SUBJECT: HOPE CREEK GENERATING STATION REACTOR OPERATOR AND
SENIOR REACTOR OPERATOR INITIAL EXAMINATION REPORT
NO. 05000354/2003302

Report No: 2003-302

FACILITY COMMENTS ON WRITTEN EXAM

NRC RESOLUTION OF LICENSEE COMMENTS

Record Number 43

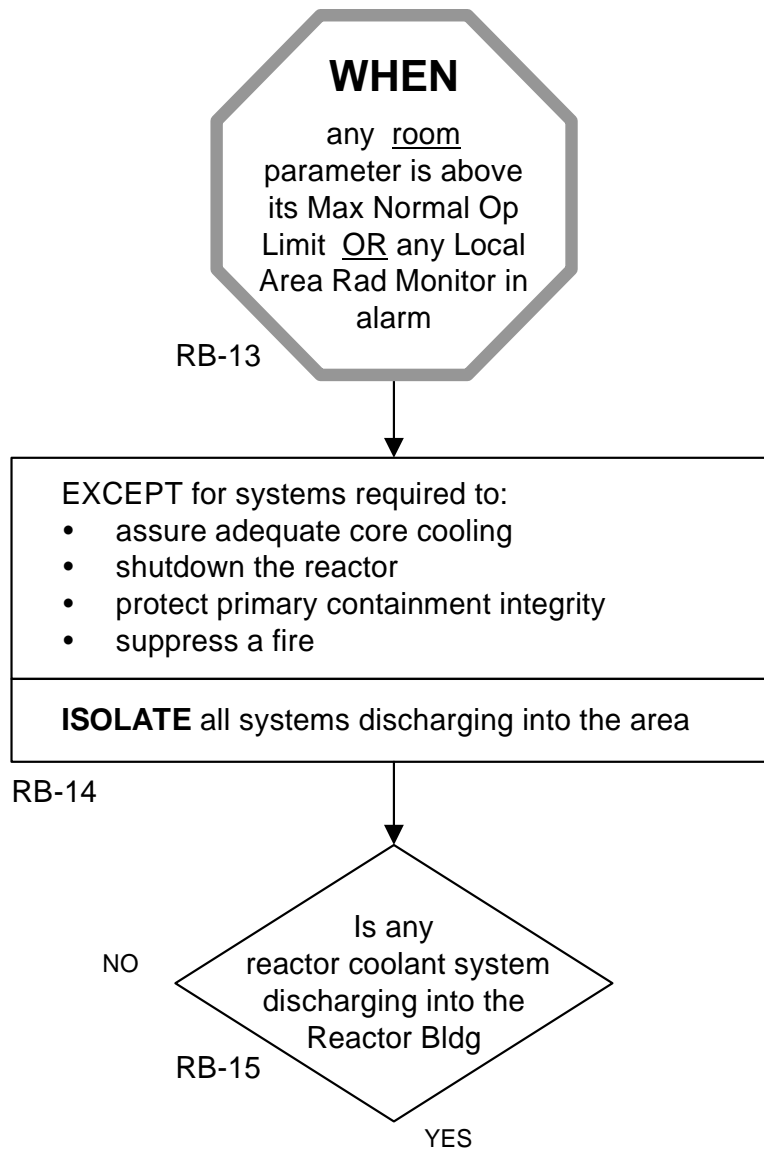
The question identified a leak into RCIC was occurring and had flooded the RCIC room and the B and D RHR room. The implication was the source being the CST, a NON Reactor Coolant System. The question asked the required actions for this condition.

Step RB-14 of EOP-103/4 requires isolating systems discharging to the area.
Step RB-15 of EOP-103/4 requires the determination if a Reactor Coolant System is discharging into the areas affected. (**see below**)

The “**NO**” response based on a leak from the CST (Non Reactor Coolant System) leaking in the Reactor Building directs actions per RB-21.

The question stem conditions based on visual observation and Reactor Building sump pump run times **placed two areas** above the Max Safe Operating Limit.

Per step RB-22 of EOP-103/4 an immediate shutdown is required. (**see below**)

The identified answer “c” was to isolate RCIC and immediately commence a reactor shutdown.

However, the choice of “Isolate RCIC” was ambiguous because it was not clear from the question that “Isolating RCIC” would isolate the leak. Two students asked if Isolating RCIC would isolate the leak. The proctor’s response was “Answer the question to best of your ability with conditions in the stem.” **See “Exam Proctor Questions” times 0945 and 1348.**

From post exam review comments, the students considered that RCIC did not need to be isolated, instead closing the suction from the CST (BJ-HV-F010) had potential to stop the leak. However, this was not an option nor did the proctor clarify the “Isolate RCIC” choice when asked.

Additional student comments stated the RCIC Isolation taken in the literal sense would not stop the leak, because the CST suction source is not included. All references to “**Isolation**” in system operating procedures do not include closure of the CST suction valve.

Recommendation: Change answer key to both “b” and “c” as correct answers.

Comment not accepted. The facility noted that isolation of RCIC by procedure would NOT stop the condensate storage tank (CST) leak and provided an excerpt from the RCIC operating procedure that showed isolating RCIC did not isolate the RCIC suction valve to the CST. Furthermore, given (as the facility also noted) that lowering CST level indicated the leak was from the CST, isolation of RCIC is not required *per the EOP*, which directs the operator to "ISOLATE all systems discharging into the area" (i.e., since the CST is discharging, isolate that system and not RCIC). Therefore, the correct answer is changed to reflect that the ONLY answer is "B".
